Product Change Notification

Change Notification #: 118670-00
Change Title: Select Intel® NUC Rugged Chassis Element
CMCR1ABB
PCN 118670-00, Label,
Label Updates
Date of Publication: November 12, 2021

Rating label with NTRL logo

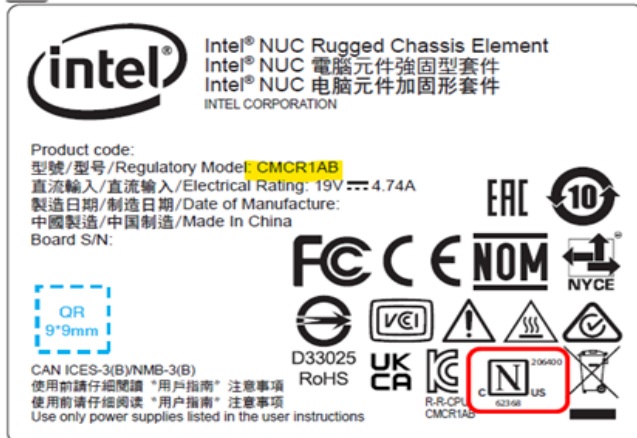
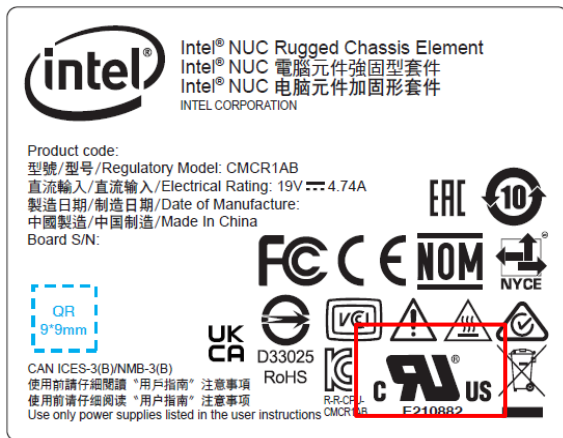
- Change CB logo on rating label from UL to NRTL due to Lab convert from UL CB to Nemko NRTL CB in AB ver.B Sku.

Box label with adding Taiwan battery recycling mark:

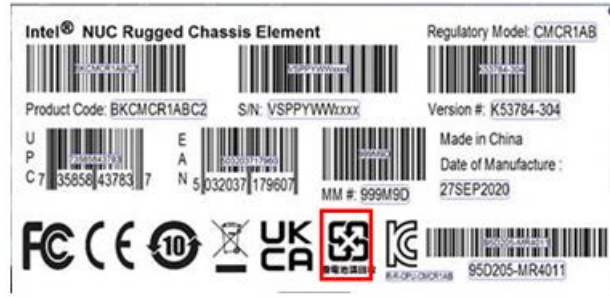
- Added Taiwan battery recycling mark on box label of AB ver.B sku.
